ALARM i30 IN DISHWASHERS WITH A THIRD SPRAYING ARM

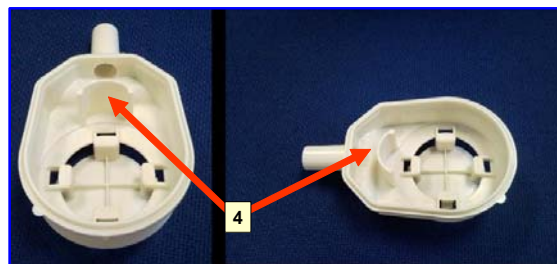
On certain "RealLife/ProClean" Dishwashers with the third spraying arm (1), sometimes a few drops of water have managed to get into the steam vent tube of the drying duct (2) and thus get into the tray at the bottom.

This may occur in the event of an accidental blockage - for instance due to a teaspoon that has not been placed in the top cutlery basket (3) properly - of the third spraying arm with the jet of water directed towards the steam vent tube of the drying duct.

The water that may build up during subsequent cycles could trip the anti-flood device and cause the appliance to break down with the i30 alarm stored.

From serial number 035xxxxx, the drying duct has been modified. A plastic wall (4) has been added inside the component to protect the outlet hole.

So even in the event of an accidental blockage of the third spraying arm, the water can no longer enter the steam vent tube.

The new spare part no. 117145821/7 was created for this purpose. It replaces and is fully interchangeable with previous spare part no. 117145820/9. If a request for the old part no. arrives (the existing spare parts lists will not be updated), only the new, modified drying duct will be supplied.
